## 2019 Project Review Sheet (2020 Construction)

<b>Project #</b>	19-134
<b>Project Title:</b>	Curb ramps and flashing beacons
<b>Location:</b>	Neighborhood: Laurelhurst, 98105 Area: Mary gates Memorial Dr. NE and Clark road

YVYC 2019: Project 19-134, Mary gates Memorial Dr. NE and Clark road

Image:

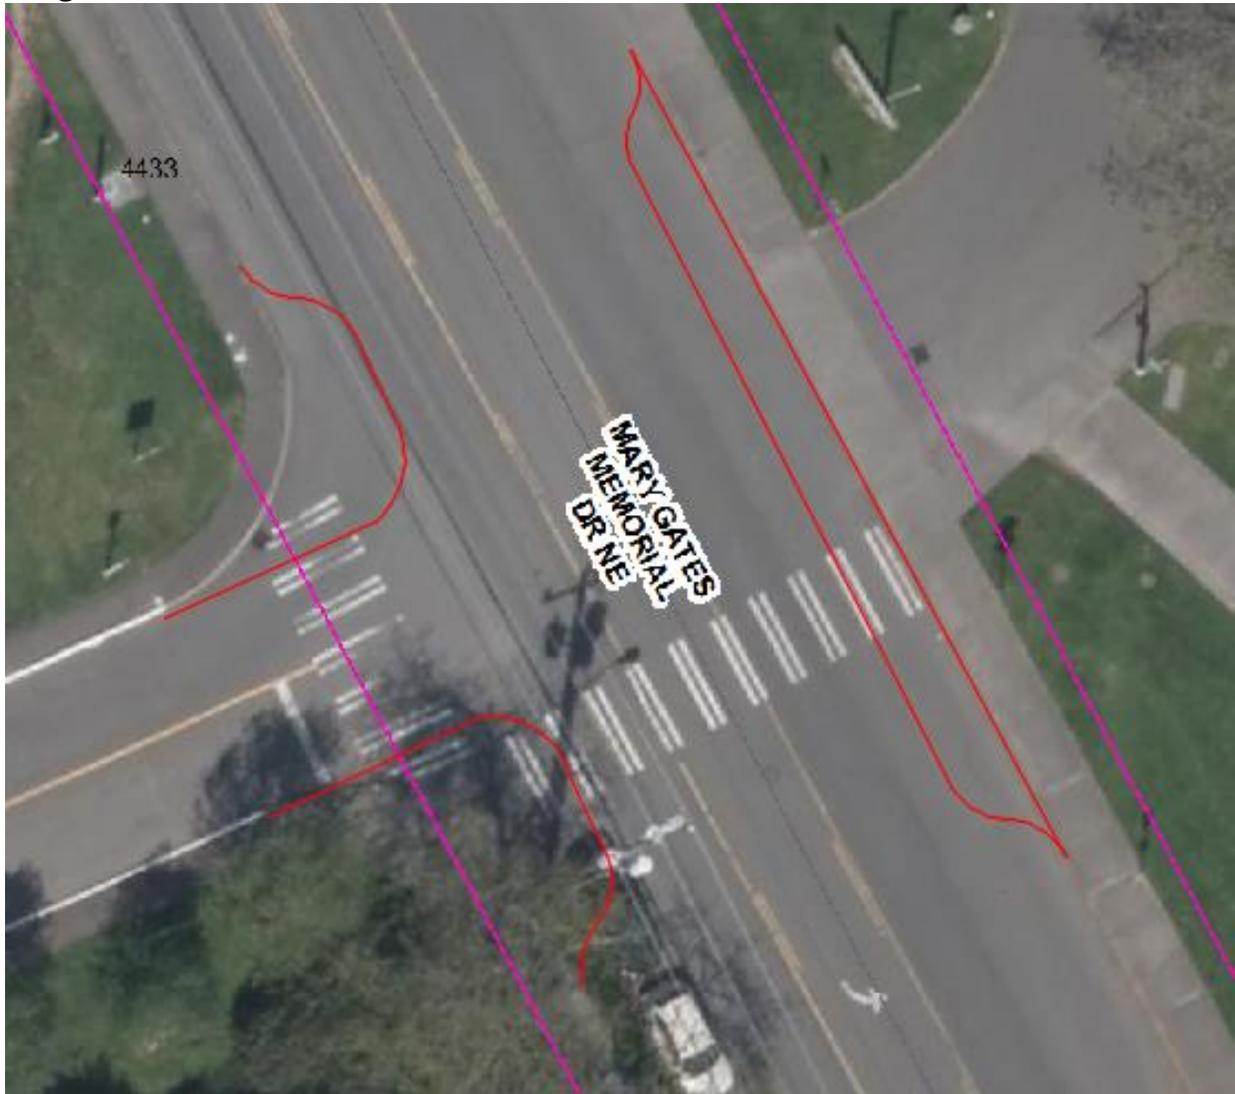
Due to the observed pedestrian crossing volumes, the intersection of Mary Gates Memorial Dr NE and NE Clark Rd does warrant pedestrian crossing improvements. Constructing pedestrian ramps and shortening the crossings is recommended if the project is selected for construction.

Curb ramps are recommended for improving pedestrian crossings. If this project was to be selected, coordination with the Bicycle Master Plan would be needed to determine what kind of treatments would be appropriate for shortening the pedestrian crossings. If possible, constructing curb bulbs on the NW and SW corners is recommended. On the east side of the intersection, bulbing out the curb and reconstructing the driveway should also be considered. If concrete construction limits future Bicycle Master Plan improvements, then paint and post treatments could be considered.

A Rectangular Rapid Flashing Beacon is not warranted at this location. Vehicle volumes are typically lower than usual.
